Rev:	Comments:	By:	Date:
A	W2-01 to be replaced.	MSIL	27-03-2020

Client:  
-  
Project Title:  
24 Heath Drive, London, NW3 7SB  
Drawing Title:  
Proposed  
Window Schedule - Second Floor

Project No.: 508-16  
Drawing No.: 6102  
Revision: A

Existing Window W2-01  
Second Floor  
Elevation

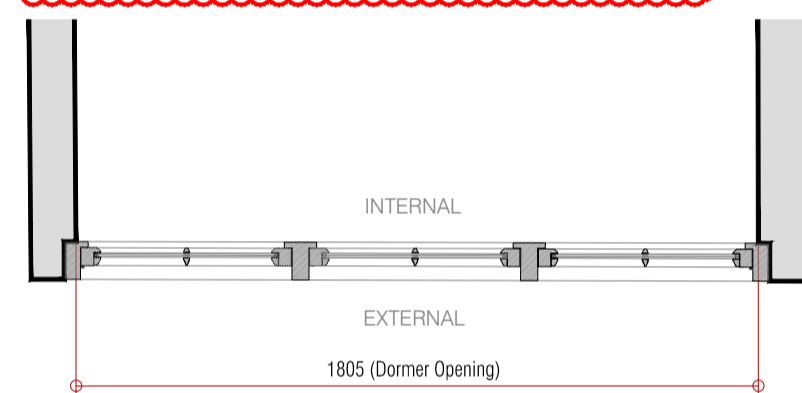
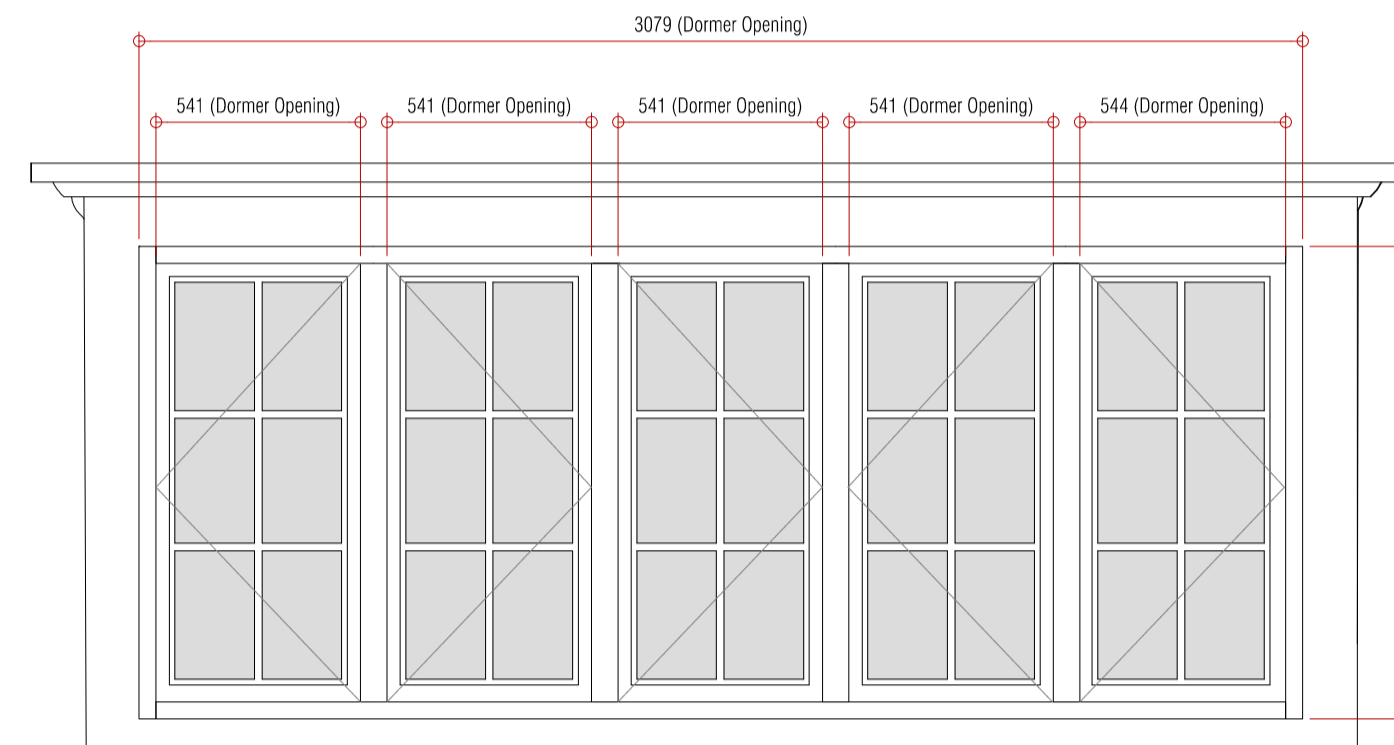
Existing window condition beyond repair, to be replaced to match existing.
